Staff Report

Re: The Twenty Ones – Design Review & Special Exception Petitions PLNPCM2019-01170 & PLNPCM2020-00200

Design Review & Special Exception

Property Address: Approximately 2105 East 2100 South
Parcel IDs: 16-22-103-001, 16-22-103-002, 16-22-103-003, 16-22-103-007, 16-22-103-008, 16-22-103-010, 16-22-103-011, 16-15-359-014, 16-15-359-015, 16-15-359-016
Zoning District: CB (Community Business)
Master Plan: Sugar House – 21st and 21st Neighborhood Plan

1 SITE PLAN - FIRE DEPT & ZONING EXHIBIT
A103 1/16" = 1'-0"

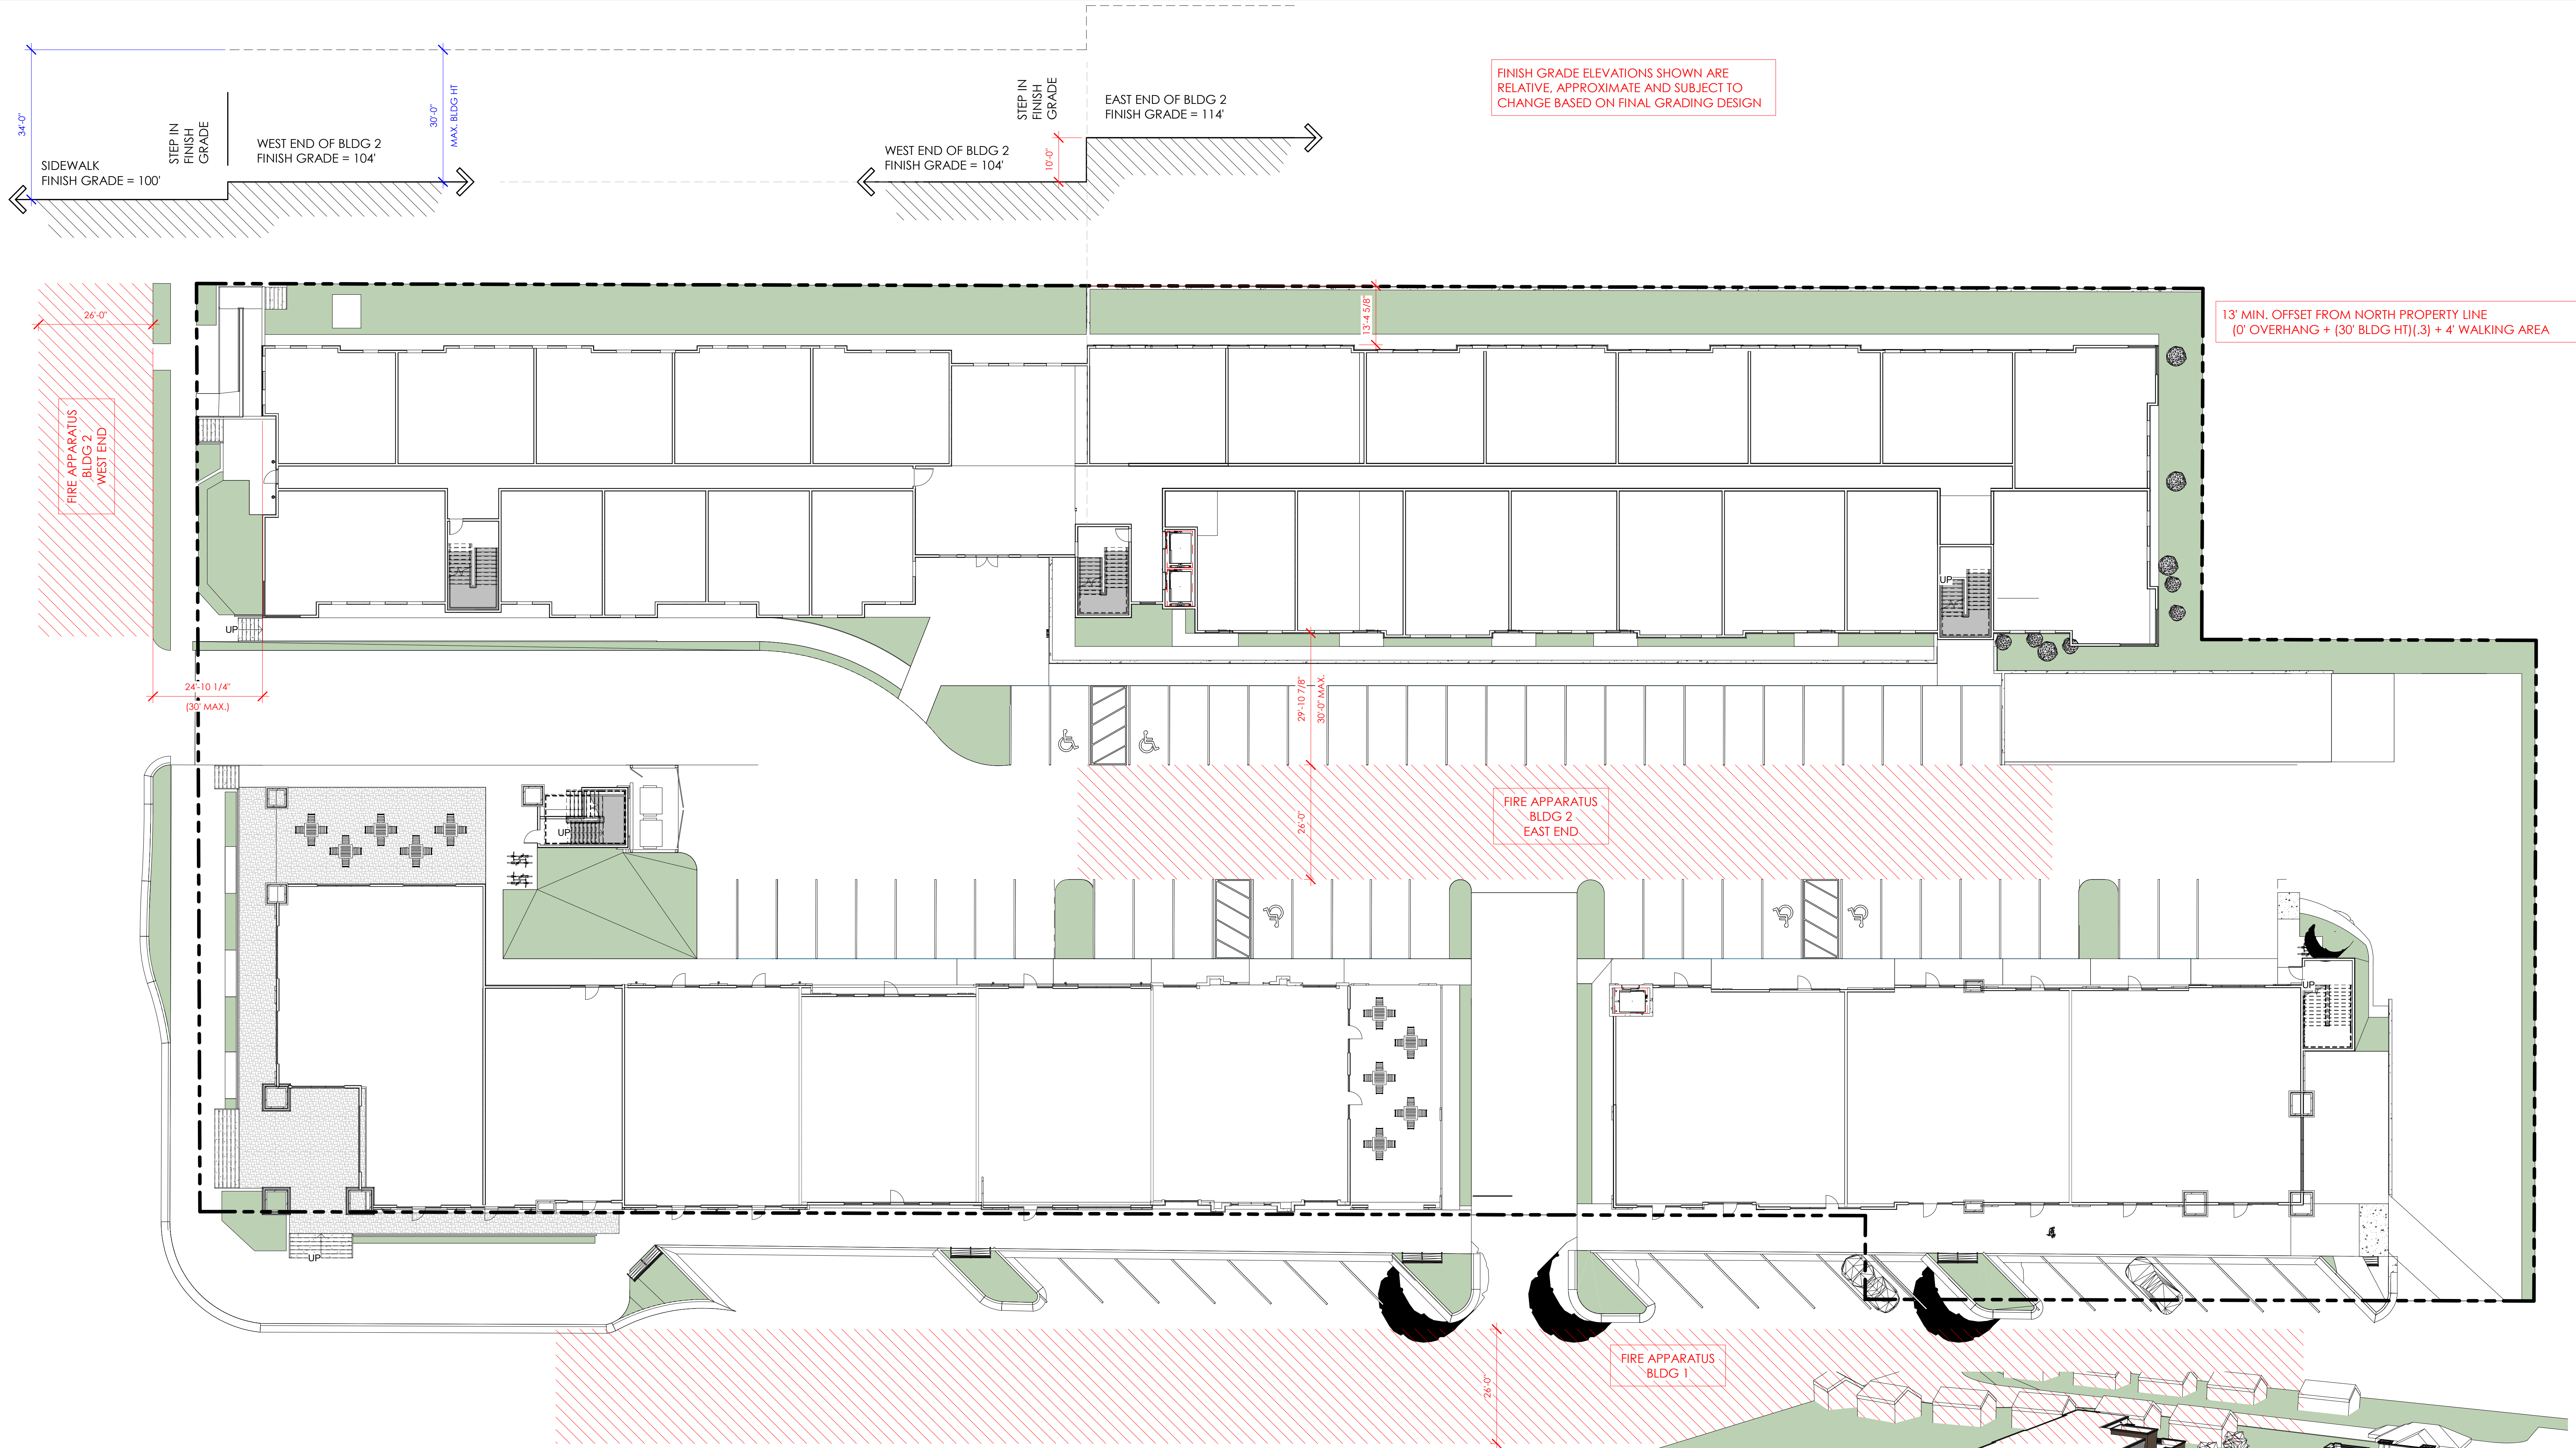
- Fire department access roads shall be a minimum of 26 foot clear width and 13 foot 6 inches clear height for which measured from the lowest fire department access road to the highest occupied floor is 30 foot and greater.
- Aerial apparatus access roads shall be located within a minimum of 15 feet and a maximum of 30 feet from the building, and shall be positioned parallel to one entire side of the building(s).
- Fire hydrants shall be within 400 feet of all exterior walls of the structure.
- Fire Department access roads that are dead ends greater than 150 feet shall be provide with a turn-around.
- The turning radius of fire department access roads are 45 foot outside and 20 foot inside.
